# 1015 DAIRY DRIVE

## TSL DAIRY INC.

GENERAL PLAN OF SERVICES

NOTES DETAILS CB DATA  
TABLE

C-010

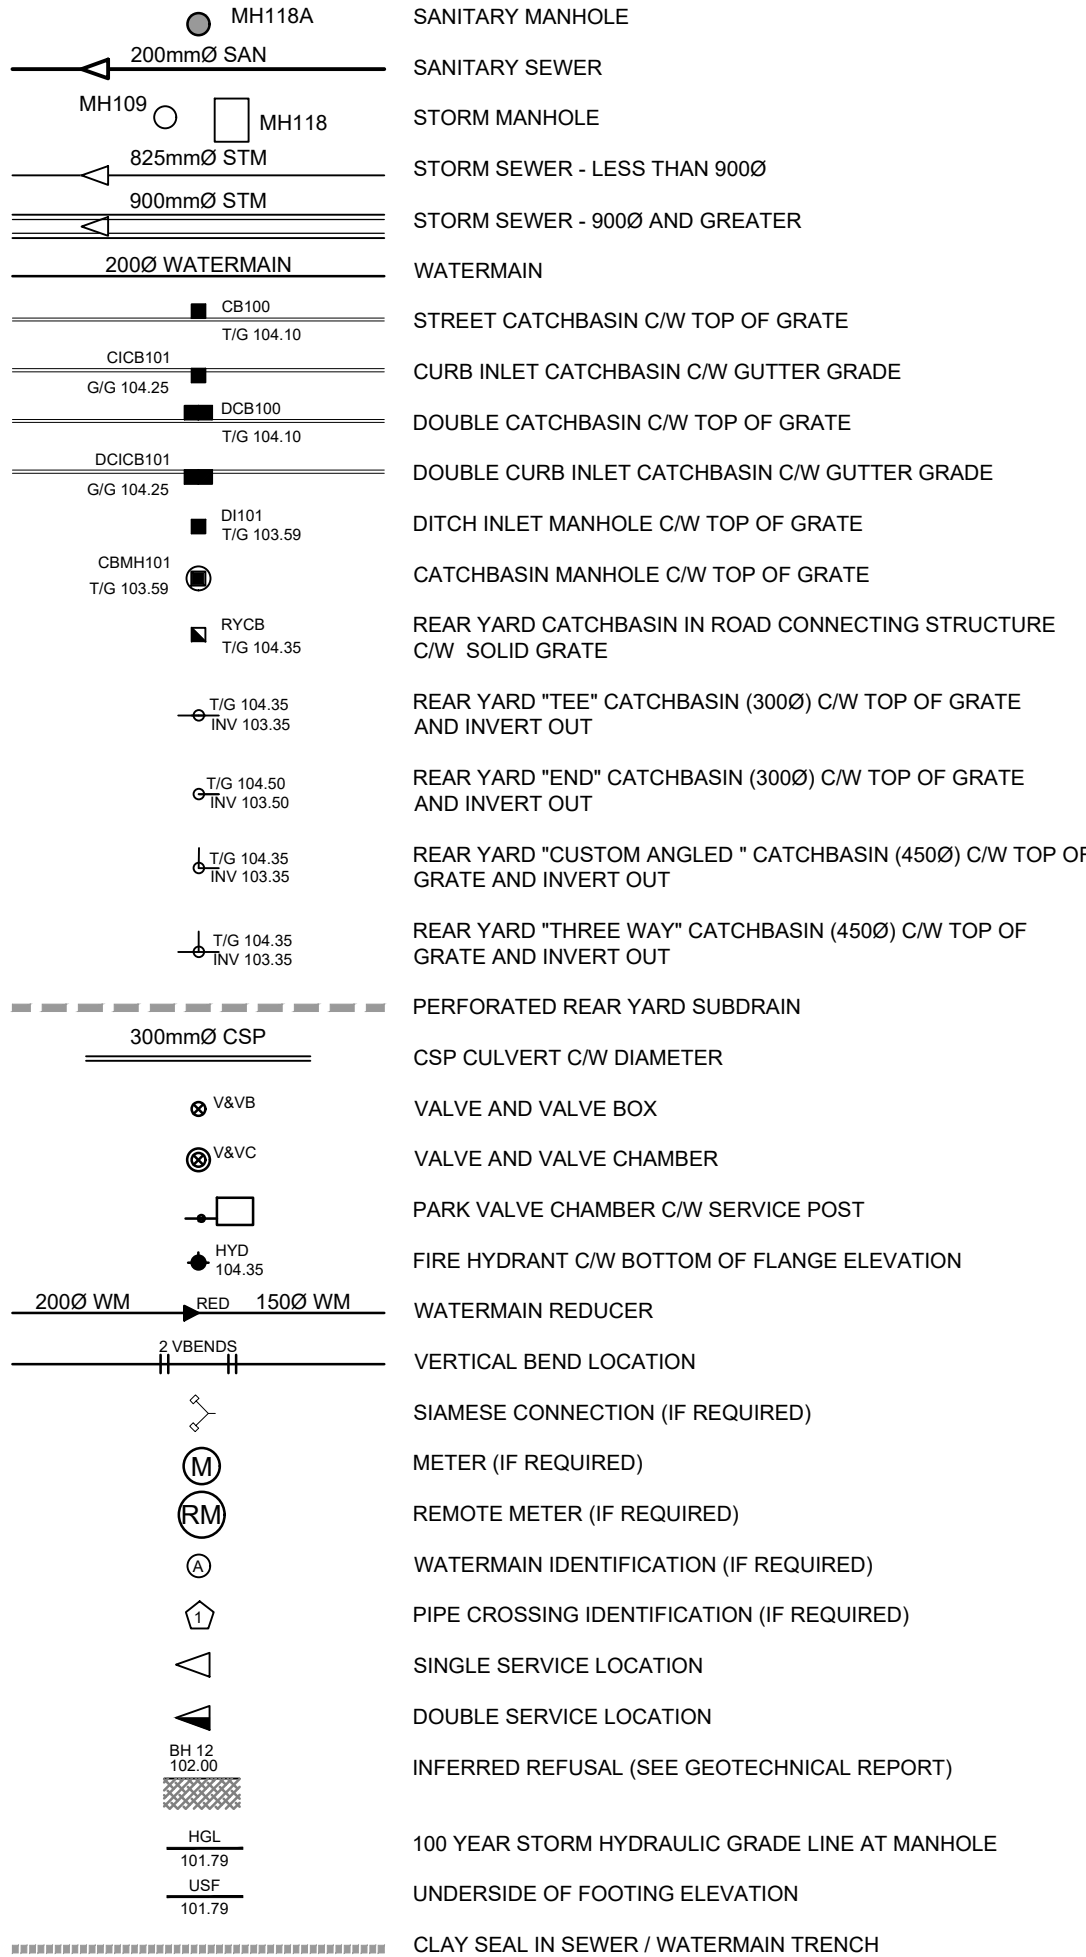
Provide notes for watermains crossing under/above sewers. City Spec W25 is to be followed for crossings under sewers, W25.2 is to be followed for crossings above sewers.

Covered under general note 1. 250mm provided for all sewer-sewer crossings, 250mm provided when water crossing over sewer and 500mm provided when sewer crossing over water.
